CROSSROADS MIXED USE FILING NO. 2

CONSTRUCTION PLANS

V4_CDs Comments.pdf Markup Summary

CROSSROADS MIXED USE FILING NO.2
STREET IMPROVEMENT PLANS

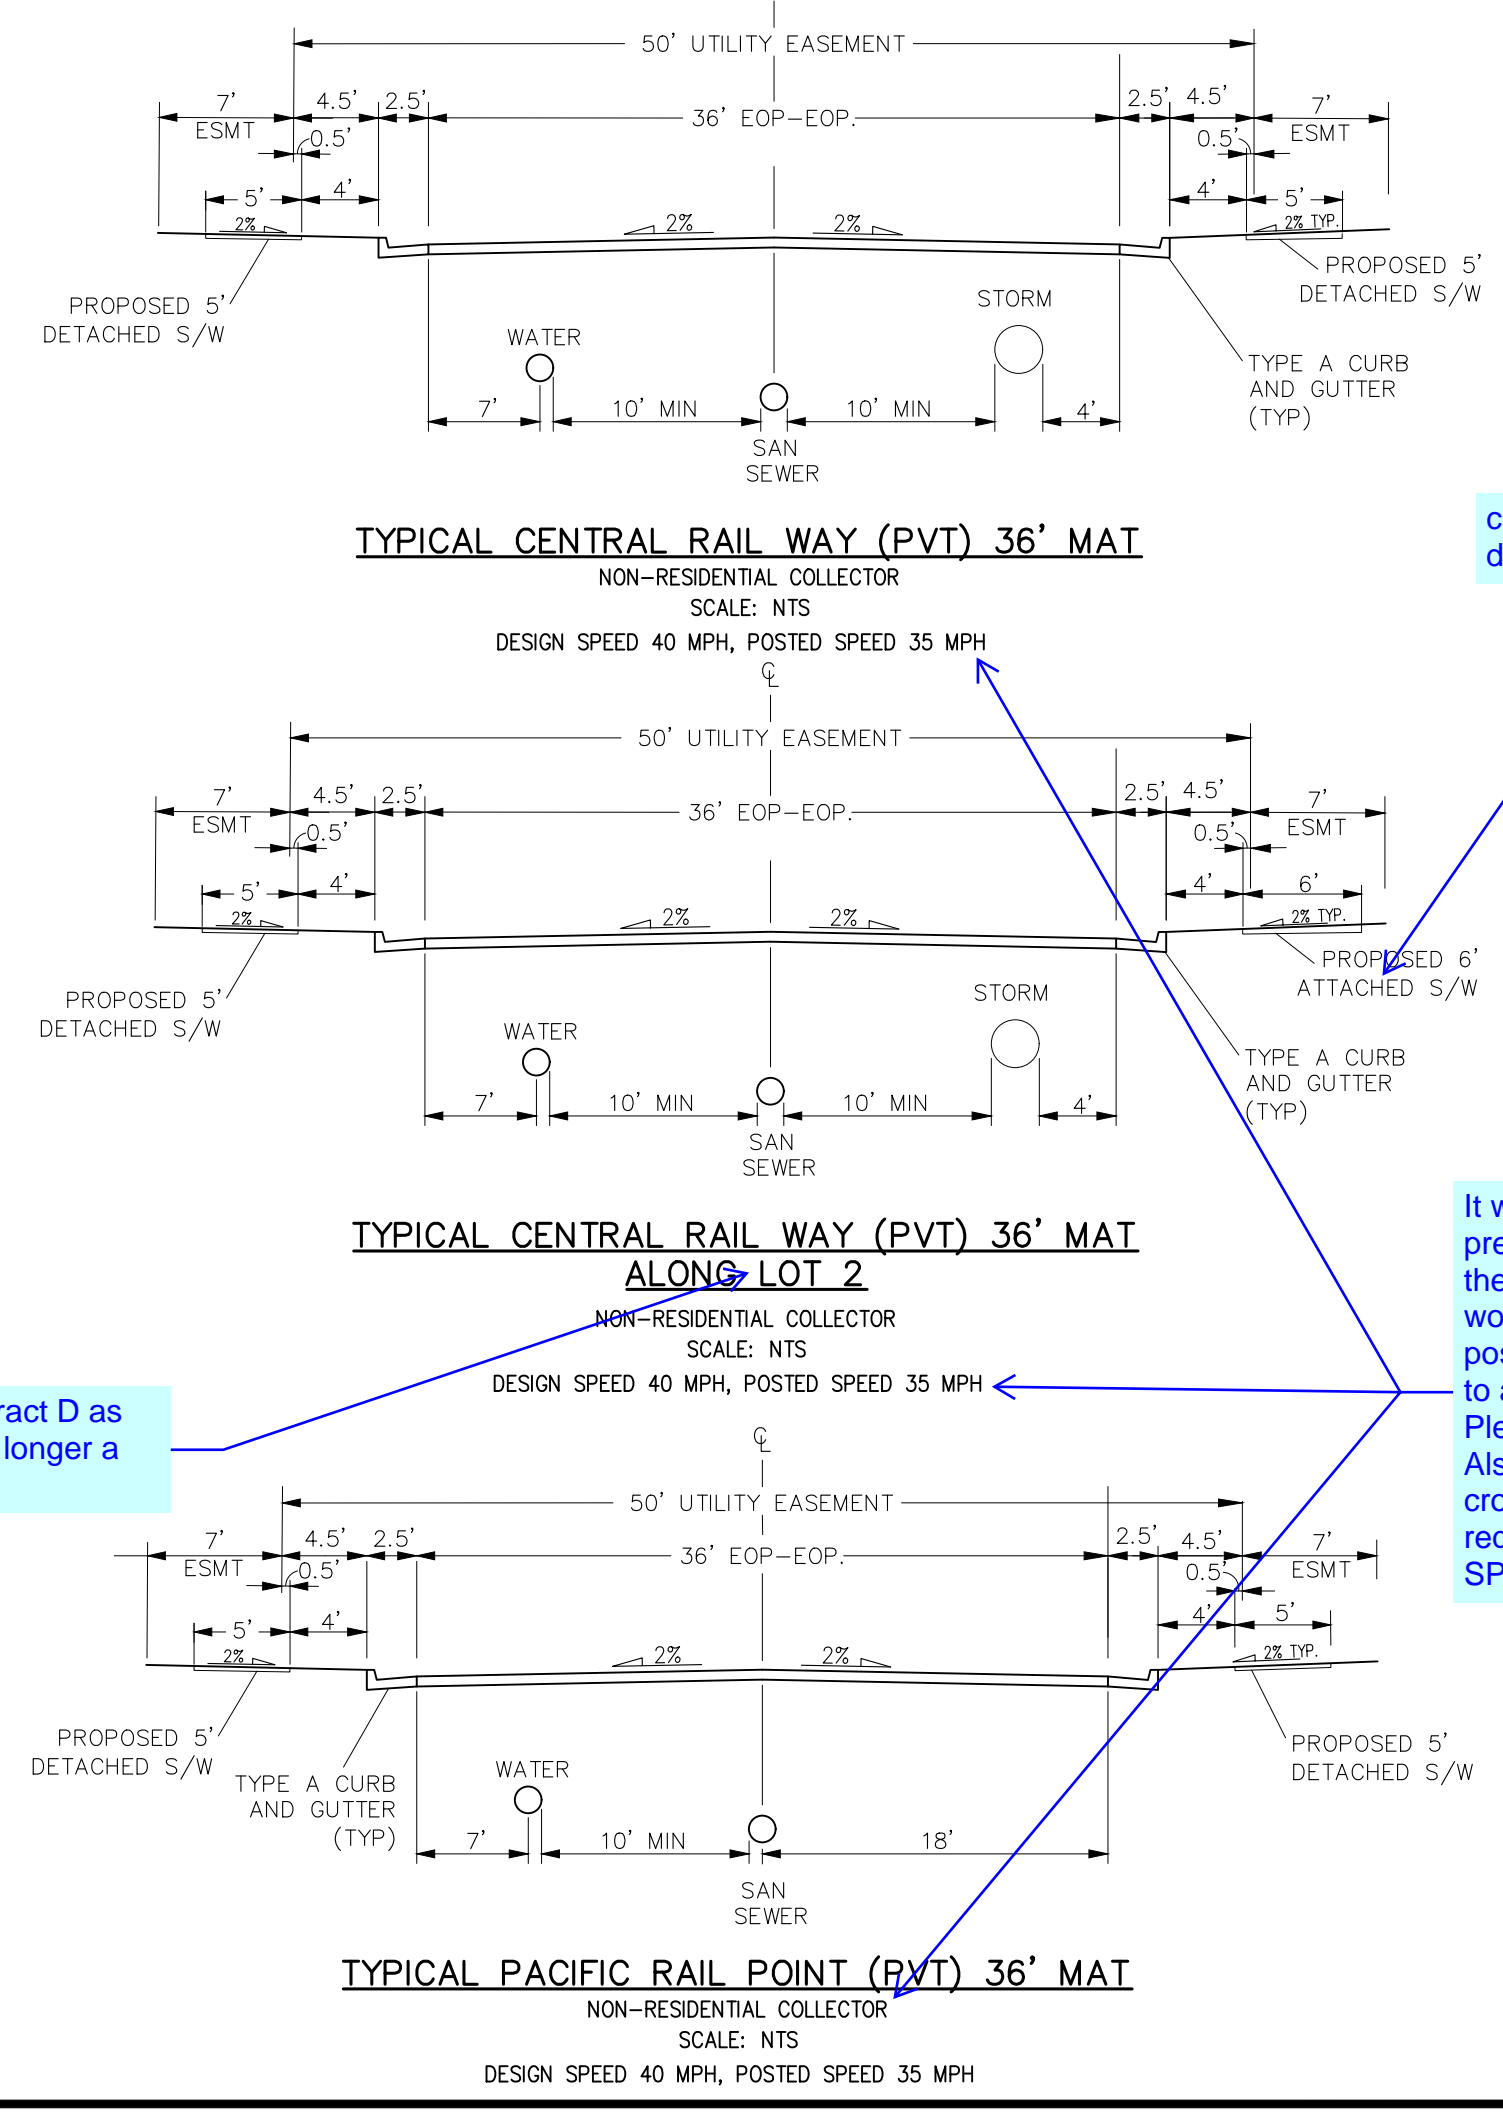
cross section shows detached. revise

It was indicated in the preliminary plan deviation and the submitted TIS that these would have a design and posted speed of 25 mph similar to a urban local classification. Please revise. Also please add note on the cross sections: per deviation request from Preliminary Plan SP2011

revise to Tract D as there is no longer a lot 2

It was indicated in the preliminary plan deviation and the submitted TIS that these would have a design and posted speed of 25 mph similar to a urban local classification. Please revise. Also please add note on the cross sections: per deviation request from Preliminary Plan SP2011

revise to Tract D as there is no longer a lot 2

cross section shows detached. revise

STREET IMPROVEMENT PLANS

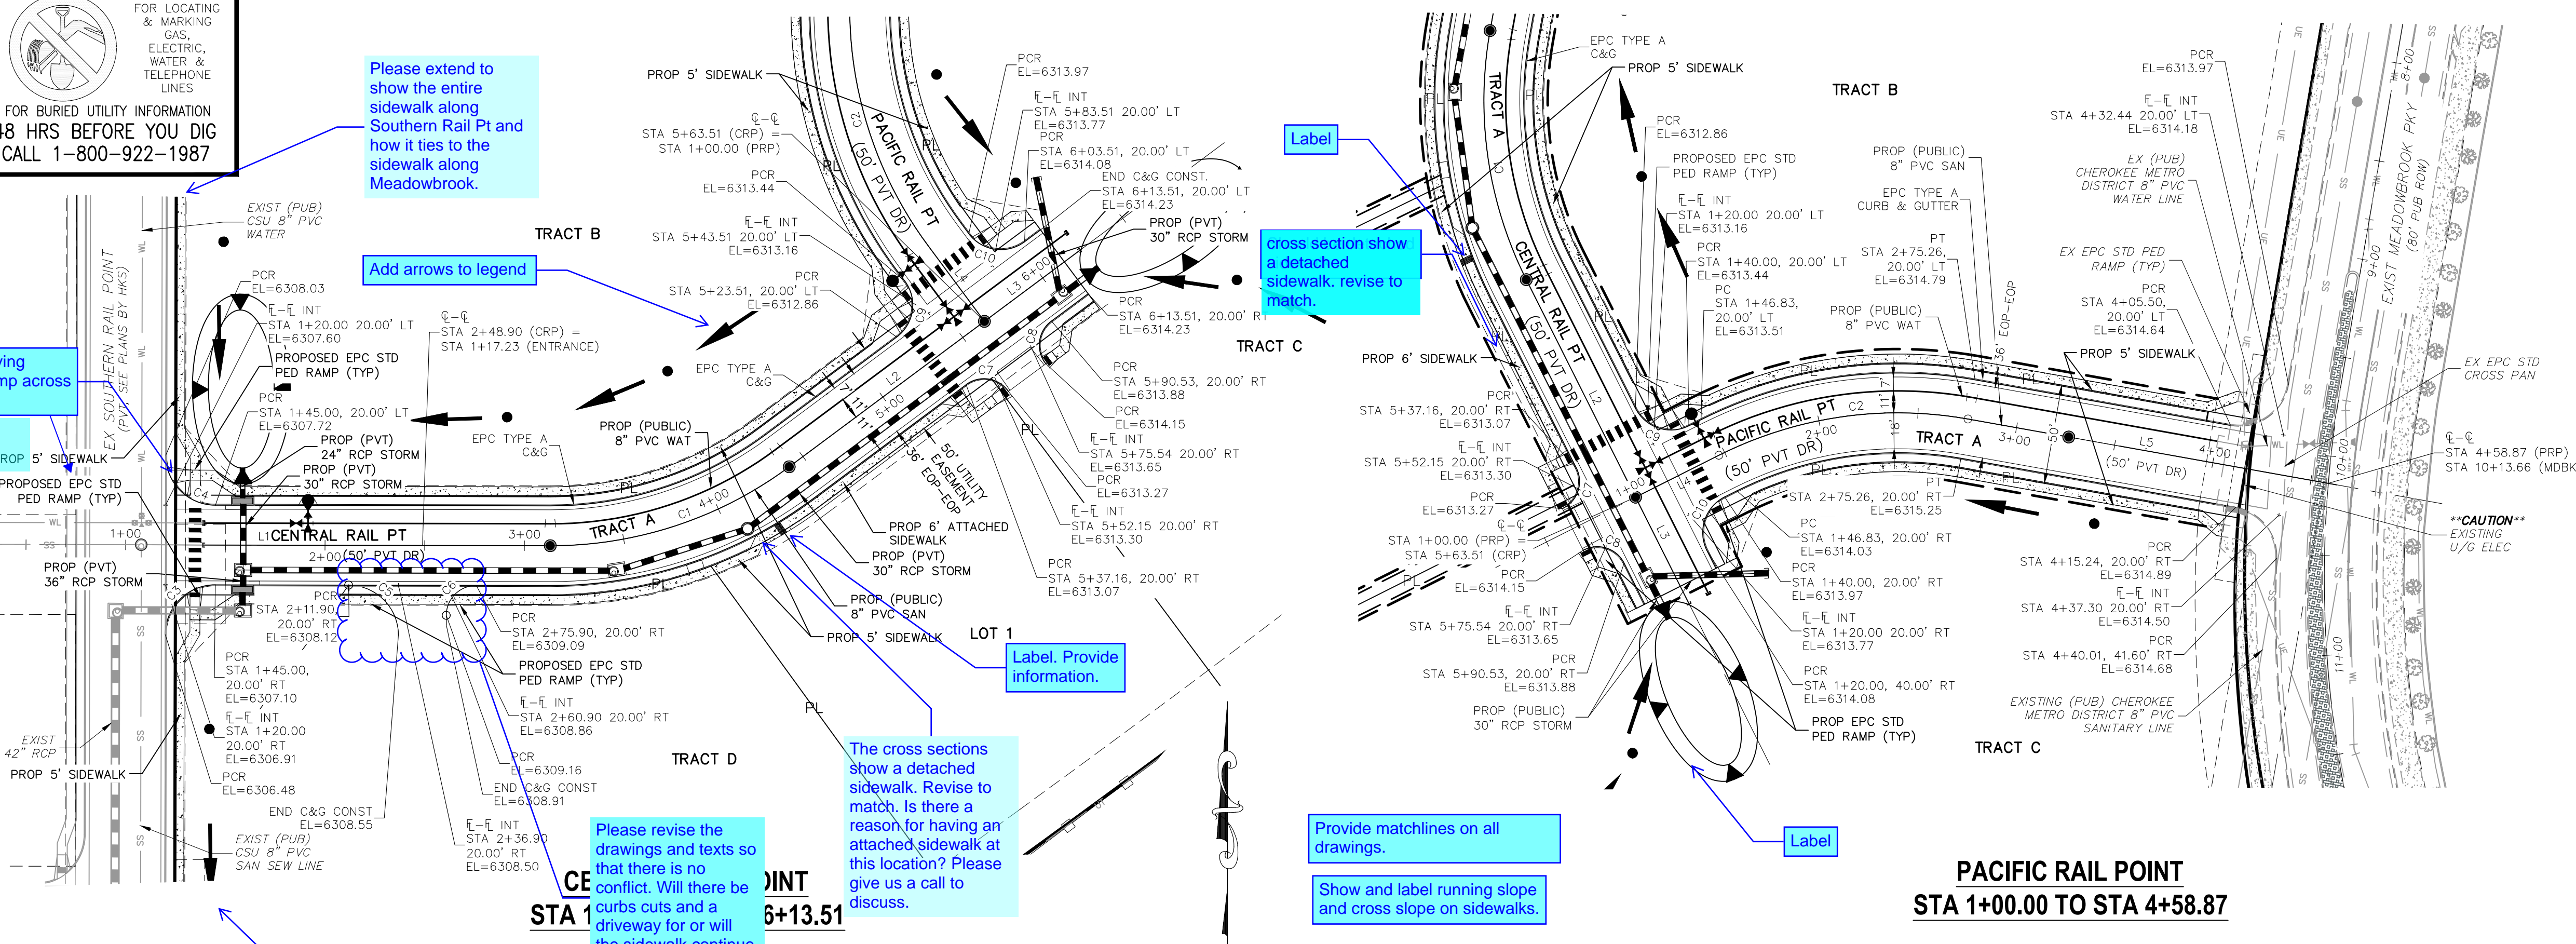
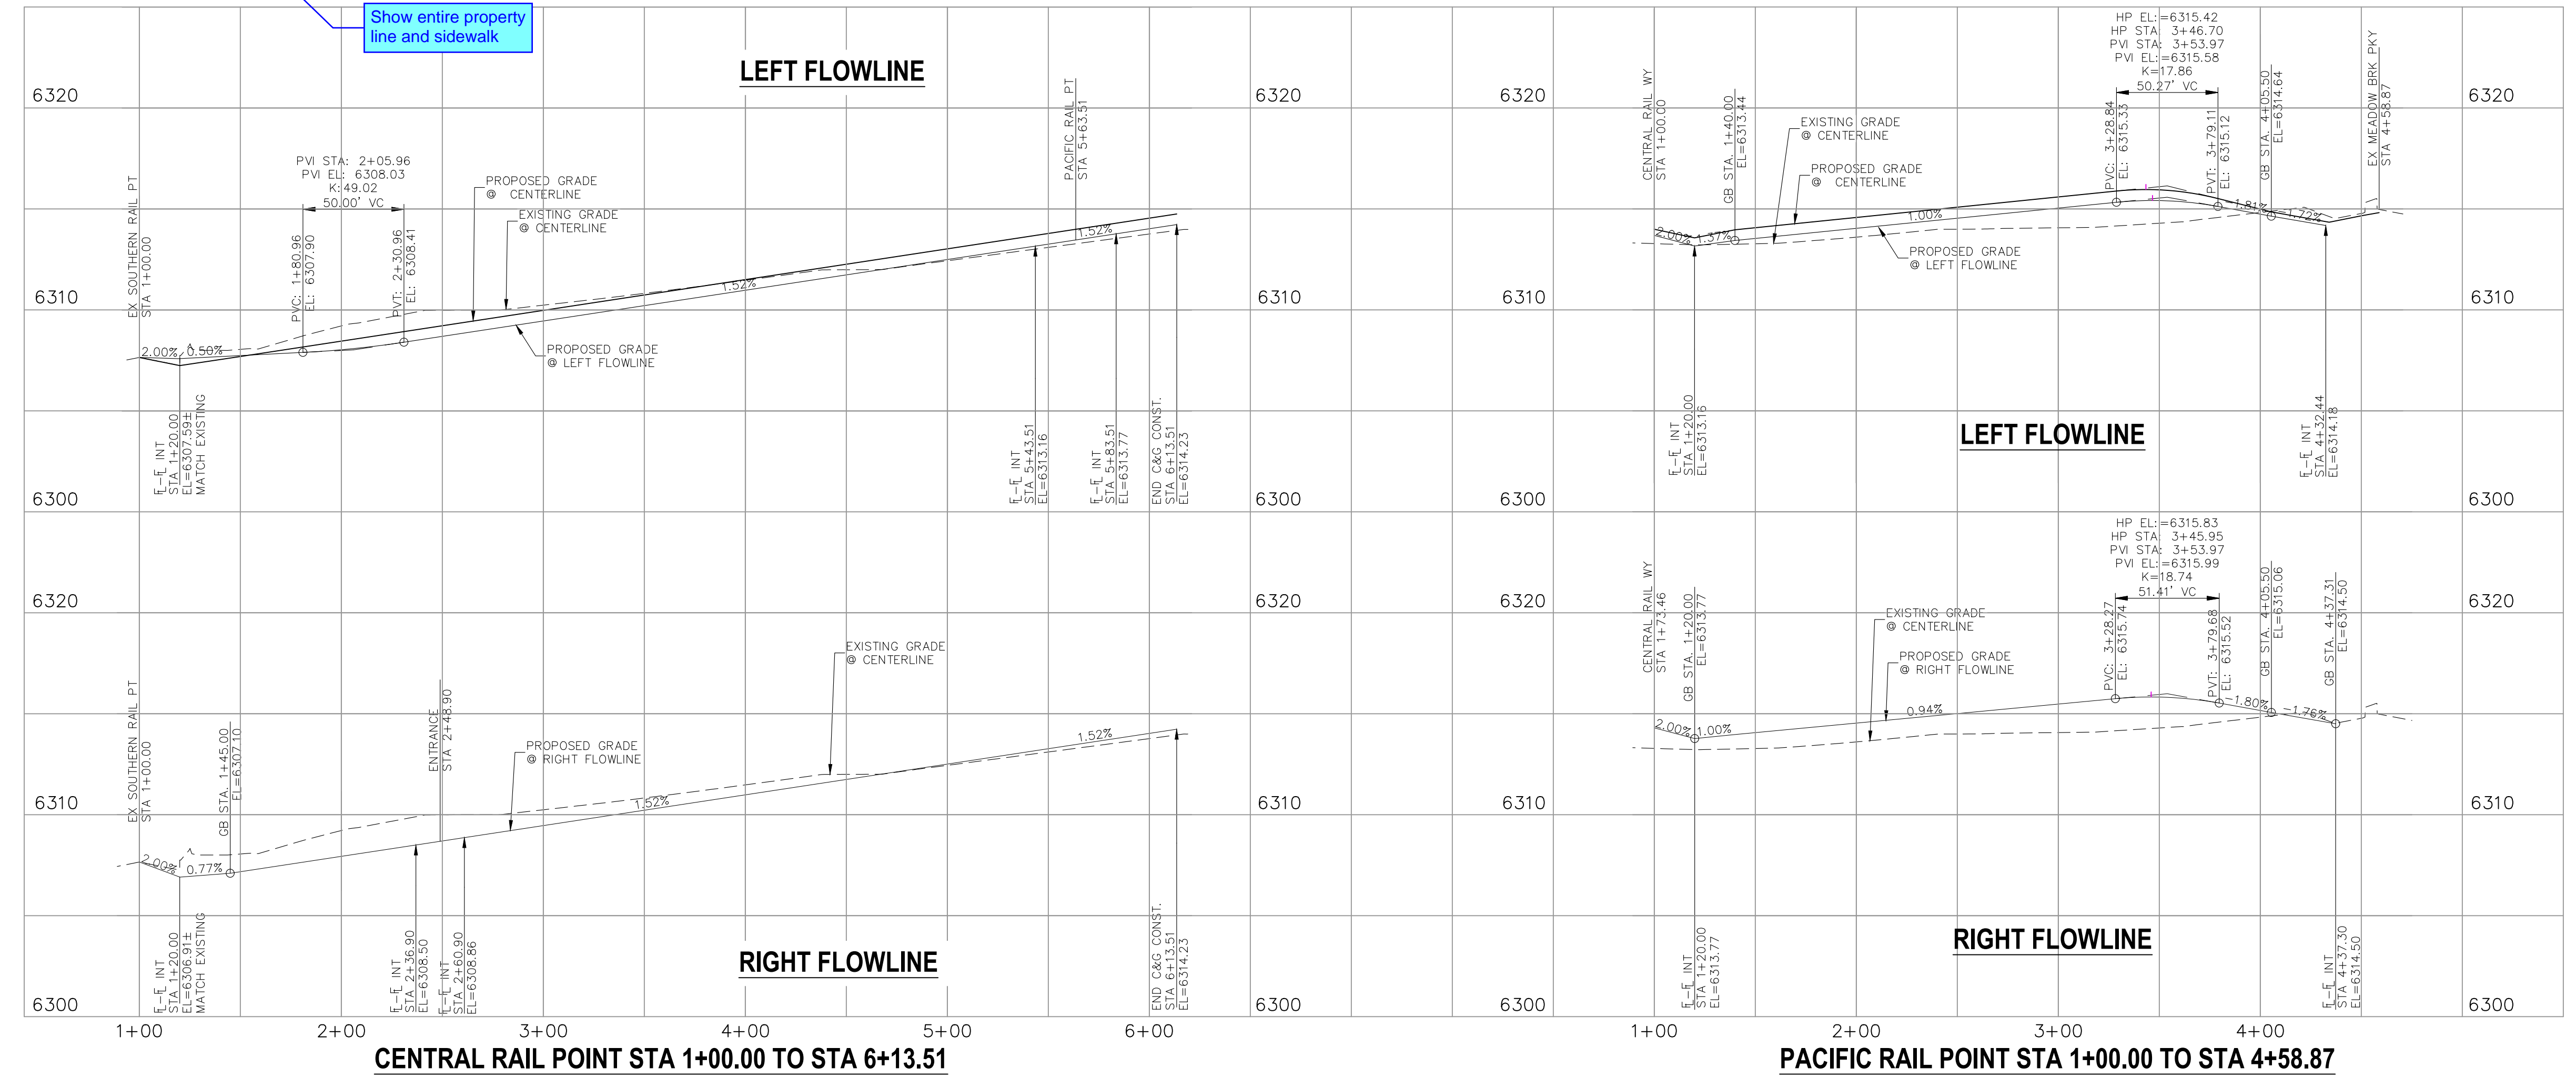
Please extend to show the entire sidewalk along Southern Rail Pt and how it ties to the sidewalk along Meadowbrook.

Add arrows to legend

Provide receiving pedestrian ramp across the street.

Refer to EDM 2.5.2.C.3

Label

cross section show a detached sidewalk, revise to match.

Label. Provide information.

Please revise the drawings and texts so that there is no conflict. Will there be curbs cuts and a driveway for or will the sidewalk continue through?

Provide matchlines on all drawings.

Show and label running slope and cross slope on sidewalks.

Provide receiving pedestrian ramp across the street.

Label. Provide information.

Provide matchlines on all drawings.

Should be detached sidewalk

Add arrows to legend

Show entire property line and sidewalk

Show and label running slope and cross slope on sidewalks.

Please revise the drawings and texts so that there is no conflict. Will there be curbs cuts and a driveway for or will the sidewalk continue through?

Please extend to show the entire sidewalk along Southern Rail Pt and how it ties to the sidewalk along Meadowbrook.

The cross sections show a detached sidewalk. Revise to match. Is there a reason for having an attached sidewalk at this location? Please give us a call to discuss.

cross section show a detached sidewalk. revise to match.

Refer to ECM 2.5.2.C.3
